# CHIPS AND TECHNOLOGIES, INC.

### CS8230 AT/386 CHIPSET DATASHEET ADDENDUM

JANUARY 27, 1989  
PA062.1/1-89  
Rev. 1.0

Followings are the addendum to the CS8230: AT/386 CHIPSet preliminary data sheet.

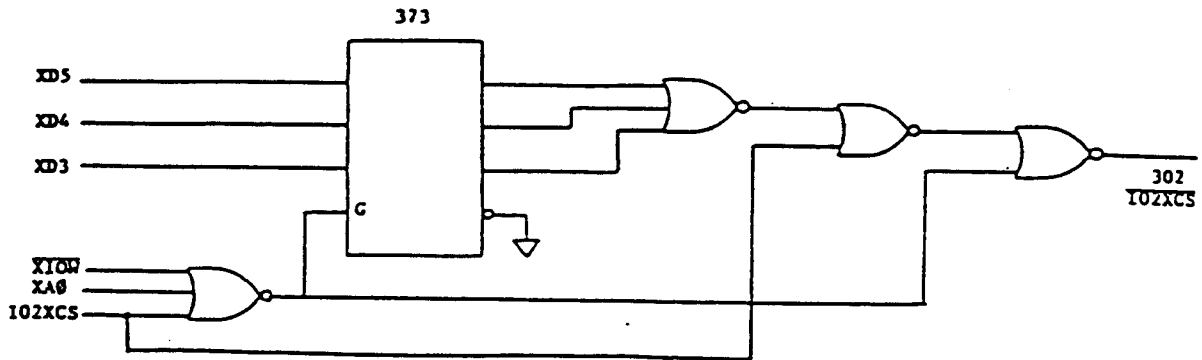
(2) **Anomaly:** Configuration register decode anomaly: The configuration register decode incorrectly responds to indices 00H to 07H. This may cause unexpected reprogramming of the 82C302.

**Fix:** The following circuit shows a temporary fix to this anomaly by preventing 82C302 from responding to accesses to index registers 00H to 07H.

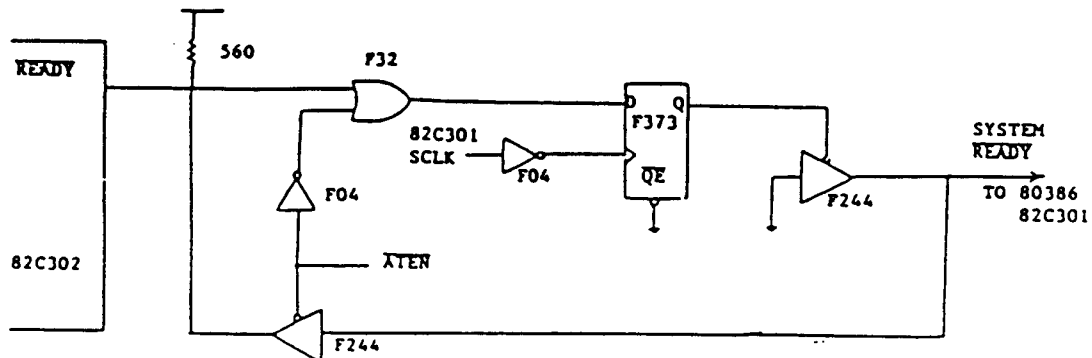
(3) **Anomaly:** The ready signal generated from the 82C302 is too early in some access cycles, such as DMA, and confuses both the 80386 and 80C301.

**Fix:** The following figure shows the external circuit required to correct this problem.

### Parity Error Anomaly

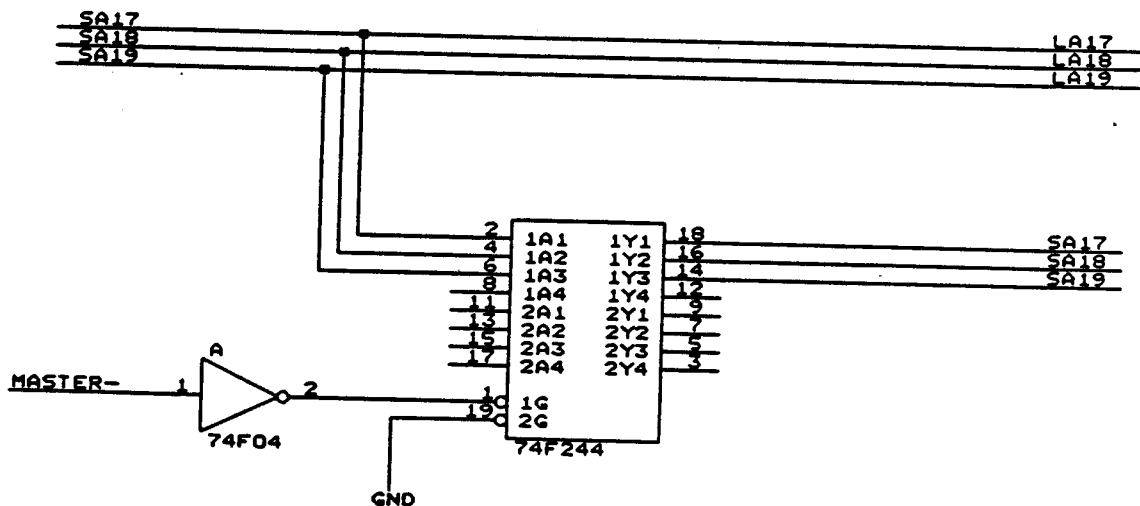
82A306 generates the parity bits during the write cycles and checks the parity bits during the read cycles. At high frequencies, due to late arrival of the Byte Enable bits (BE0- thru BE3-), the parity logic generates parity error during the partial\_double\_word read cycles. To avoid this problem, connect the FBE- from 82C302 to the FBE- of 82A306. By doing this, all the read cycles will be a 32-bit read and the BE- bits will be ignored by the parity logic.
